The Town of Erie

To: Matt Janke and Chris Elliott, MR Erie, LLC
From: Hannah Hippely
Date: January 25, 2019
Re: SK-000978-2018 – Spring Hill Sketch Plan Application
cc: Deborah Bachelder

To: Hannah Hippely
From: Chad Schroeder, P.E., CFM, Development Engineer
Date: December 21, 2018
Subject: **Spring Hill Sketch Plan**
CC: Matt Wiederspahn
Wendi Palmer

Comprehensive Plan Map

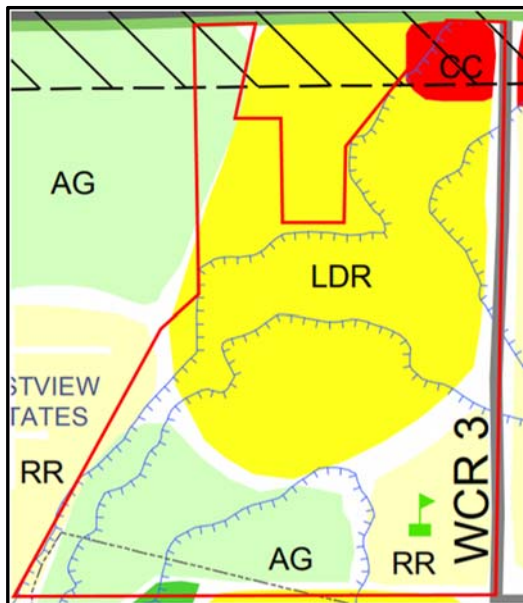
- a. All of the uses proposed by the sketch plan are permitted within the LR Zone District and the zoning allows for all of the land use designations of the Comprehensive Plan.
- b. The proposed sketch plan is not consistent with the Comprehensive Plan Agriculture (AG) land use designation for this property.
 - i. Approximately 70 acres in the south portion of the property is designated as Agriculture (AG) on the Comprehensive Plan. According to the Comprehensive Plan farming, ranching, and other agriculturally related uses and very low density rural residential uses

- are appropriate in this area. Also, lands designated Agriculture “serve a vital role in defining the history and character of Erie and should be maintained where viable, to serve as gateways and buffers, preserve vistas, and retain the desired character of the Town.” Within this area the plan shows the western edge, the areas adjacent to the western two ditches (Lower Boulder Ditch and the Boulder/Weld Ditch), as open space and develops the remainder at a density consistent with an LDR land use designation.

- ii. The LR Zone Designation does not negate the need for the subdivision to be consistent with the Comprehensive Plan. A Comprehensive Plan land use map change would need to be approved if the subdivision is not redesigned to be consistent with the Comprehensive Plan.

Zoning Map

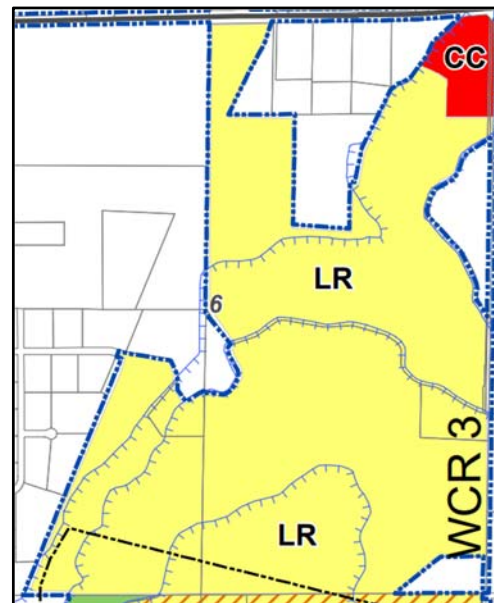
- c. It appears that over all residential densities comply with the Comprehensive Plan and Zoning Map.
 - i. Tract Q, which is located along the western edge of the development adjacent to the rural Weld County subdivision and the south east corner of the property are two areas designated RR on the Comprehensive Plan where residential densities of 0-2 dwelling units per acre (du/ac) and gross density not to exceed 1 du/ac is expected.

- d. The Comprehensive Plan and the Zoning Map show a flight cone associated with the Parkland Airport over southern portions of the property. The applicant will need to coordinate with the Parkland HOA as part of the preliminary plat process.
